RE: Transportation Safety Technologies, Inc.

FCC ID: NVX-TST-RFT210

Revised Duty Cycle Calculation

Duty Cycle Plot, 200ms Pulse Train Repetition

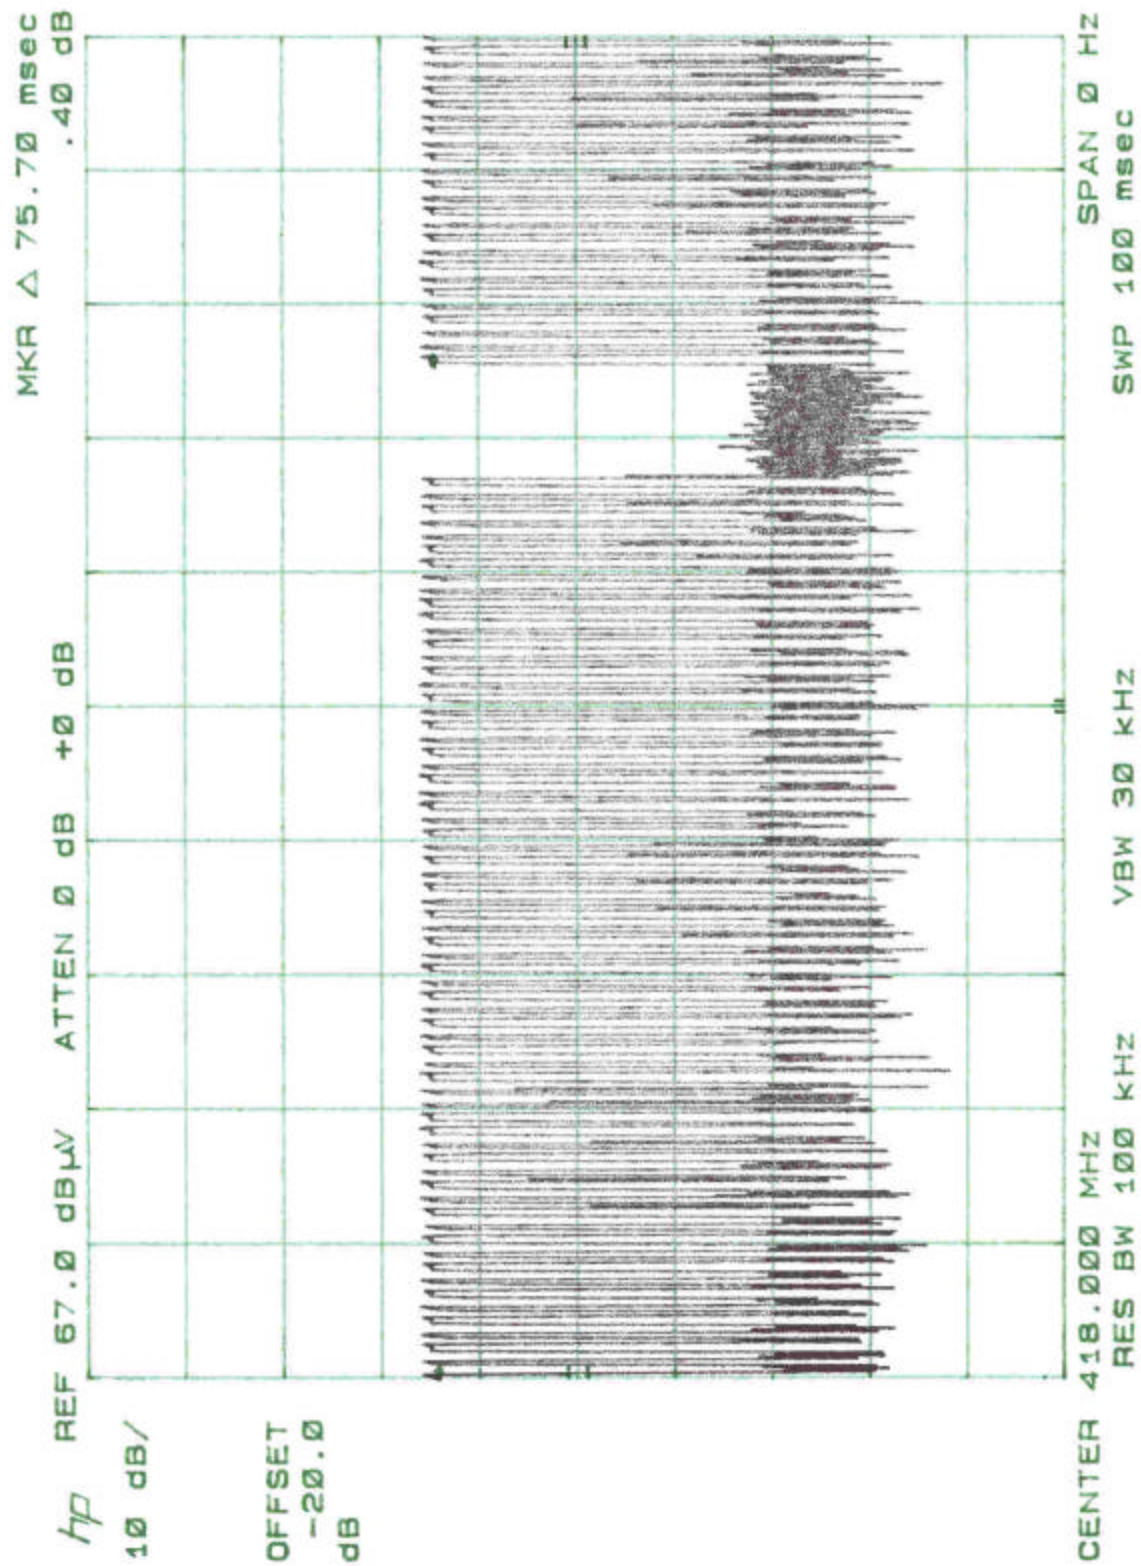
From the 200ms plot the length of a single pulse train is 75.7ms.

$$27.36\text{ms} / 75.7\text{ms} = 36.14\% \text{ or } -8.8\text{dB}$$

Duty Cycle Plot, 100ms, 75.7ms Pulse Train

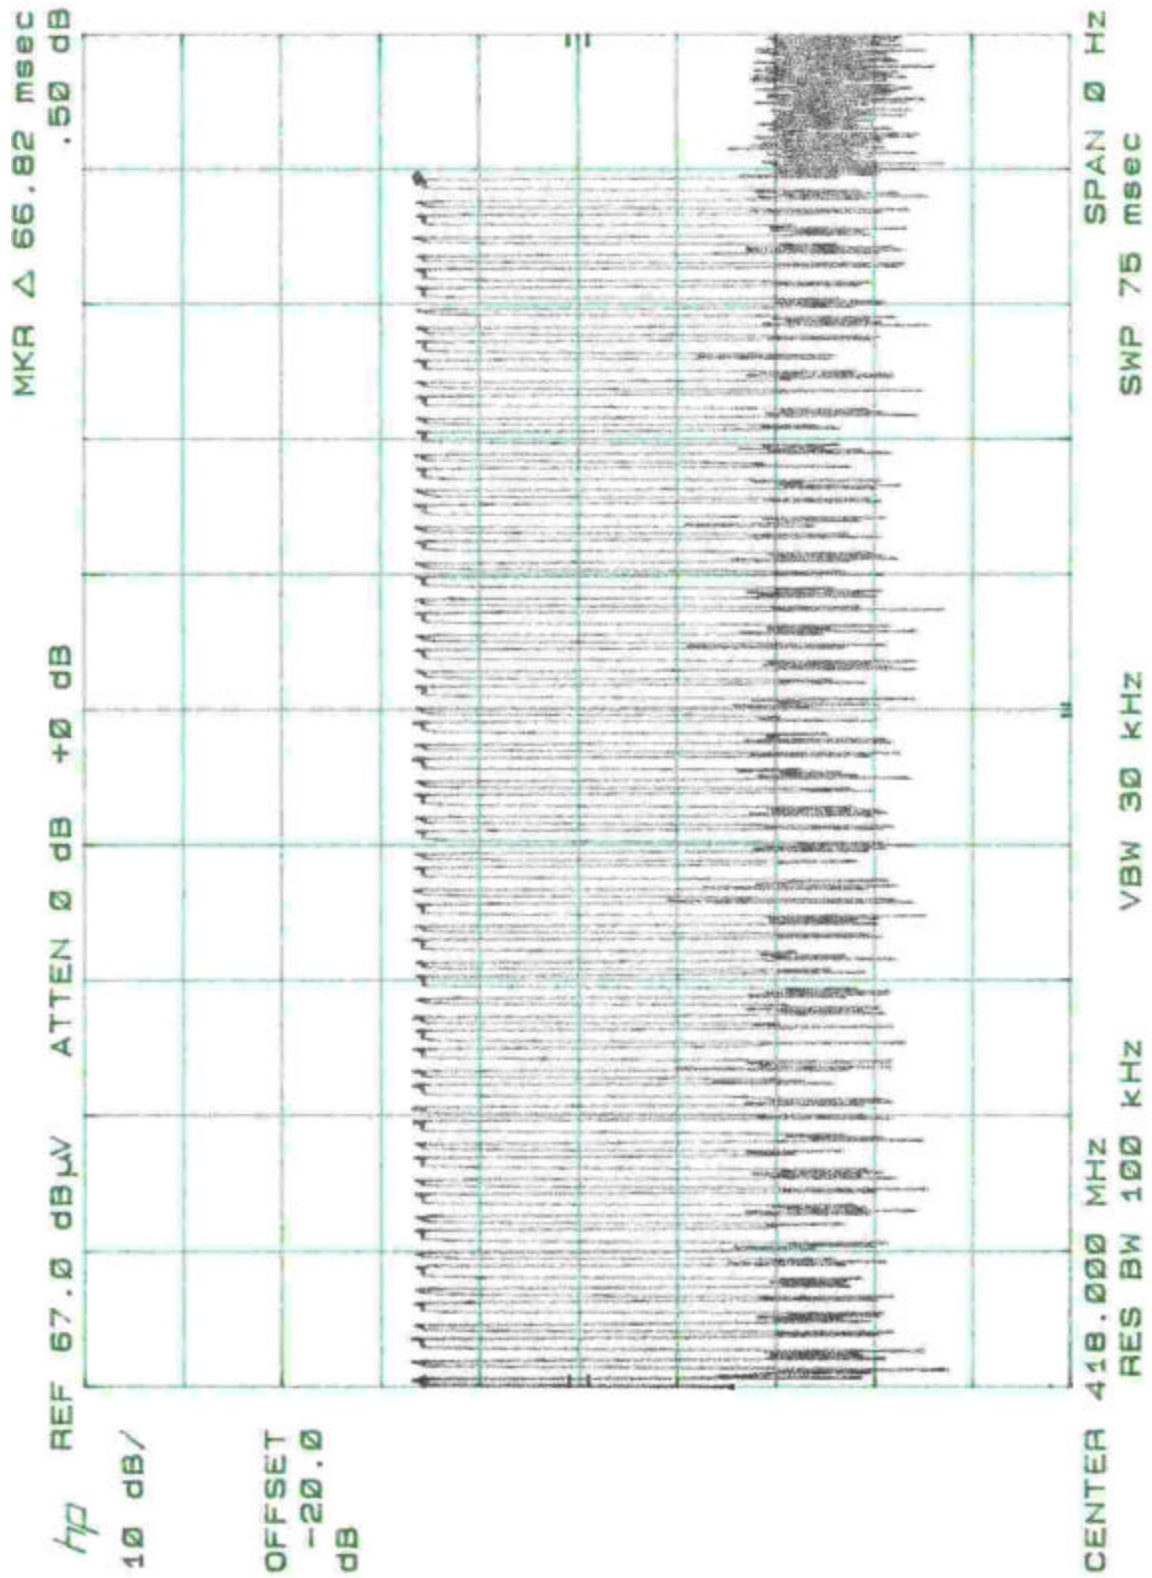
Based on the new duty cycle plots obtained in the normal mode, the EUT would have a worst case on time of 27.36ms. This is calculated as follows:
